**FOURTH FIVE-YEAR REVIEW REPORT FOR  
STANLEY KESSLER SUPERFUND SITE  
MONTGOMERY COUNTY, PENNSYLVANIA**

**U.S. Environmental Protection Agency  
Region 3  
Philadelphia, Pennsylvania**

Figure 4: Potentiometric Surface Map

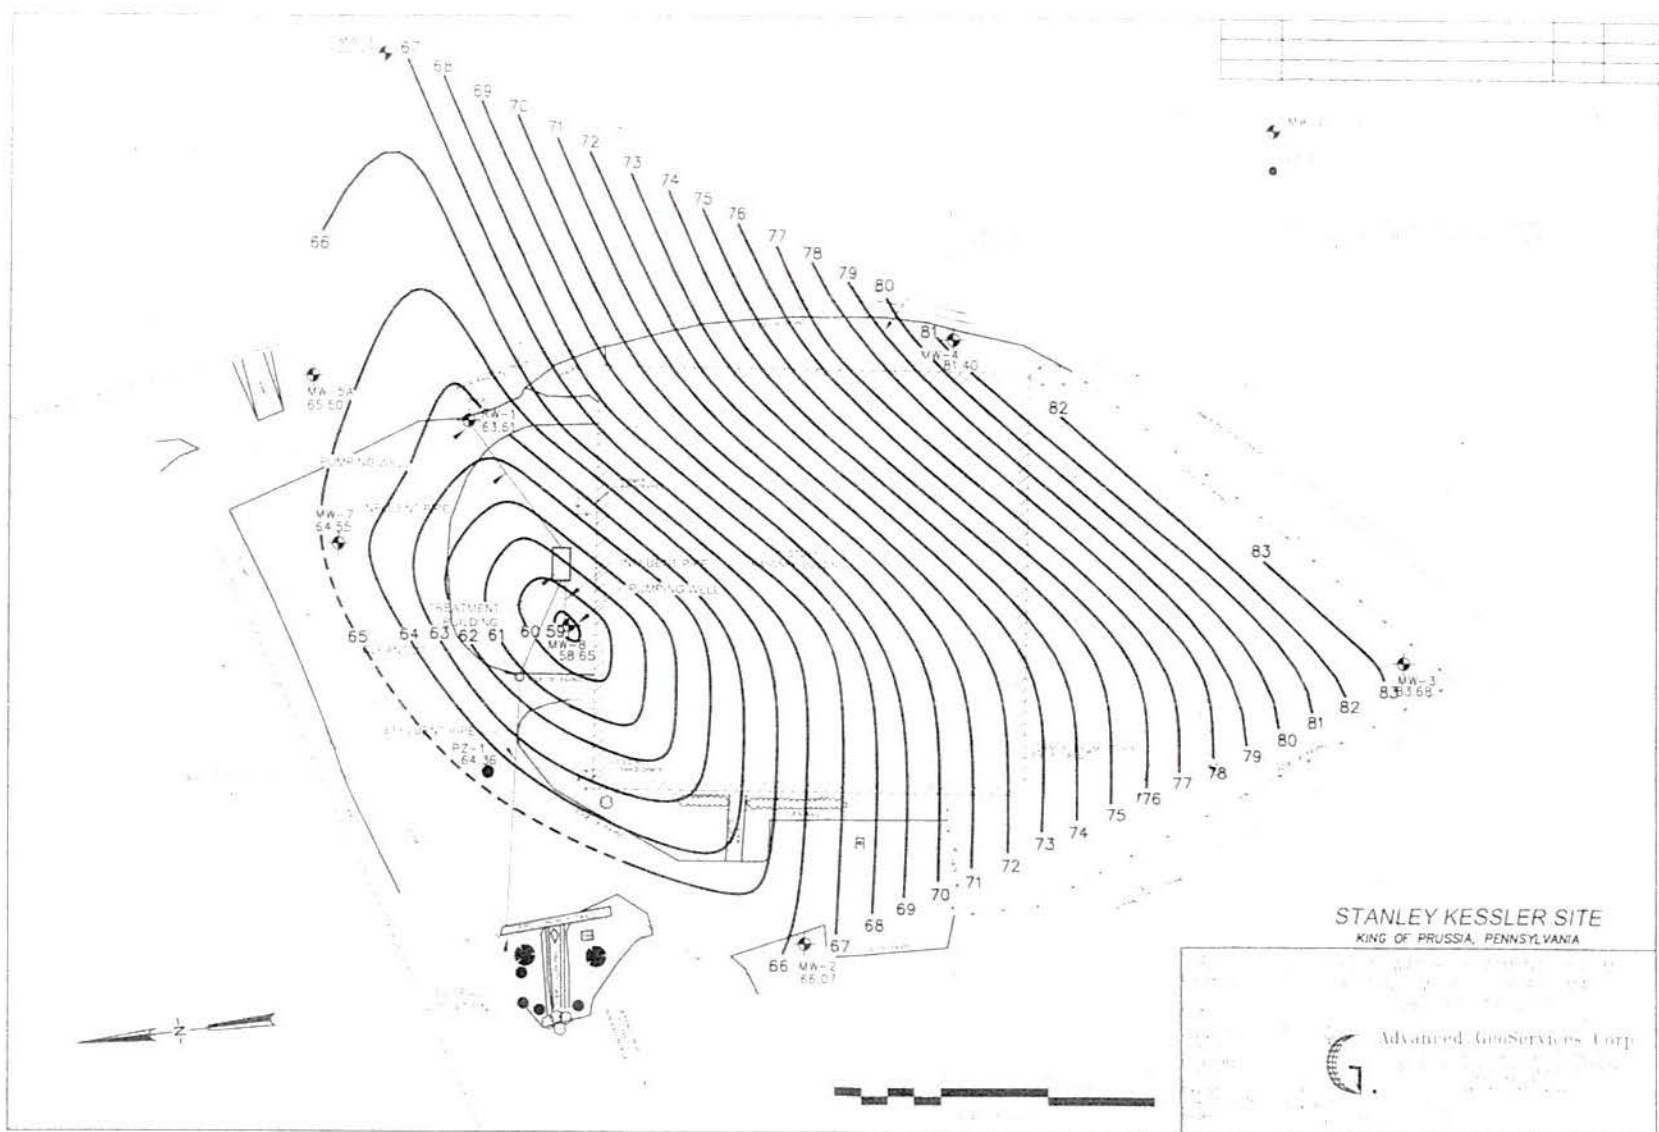
The data review began with an examination of the potentiometric surface maps created using groundwater elevation data that is collected monthly at the Site. A recent potentiometric surface map dated February 14, 2019 (Figure 4) represents the current pumping scenario of about 40 gallons per minute (gpm) (about 30 gpm at RW-8 and about 10 gpm at RW-1), and suggests capture of contaminated groundwater north of the Site building,

immediately downgradient of the source area. However, the influence of the recovery wells on downgradient monitoring wells MW-7, MW-5A and MW-6 is less clear.

Consistent with recommendations made in the 2014 FYR, the PRPs submitted a capture zone analysis to EPA in May, 2015. Upon review, EPA concluded that an additional monitoring well may be necessary downgradient of MW-7. However, due to the fact that two monitoring wells from another nearby Superfund Site are already located approximately 500 feet downgradient of MW-7 and do not show elevated concentrations of Site COCs (see Tables 1 and 2), EPA concluded an additional monitoring well is not necessary at this time. EPA will continue to evaluate groundwater COC concentrations downgradient from the extraction wells to determine if additional monitoring wells are necessary.

1. Continue to evaluate groundwater COC concentrations downgradient from the extraction wells to determine if additional monitoring wells are necessary.
2. Continue to evaluate the influence of the recovery wells on downgradient monitoring wells MW-7, MW-5A and MW-6 to determine if optimization of the GETS is necessary.
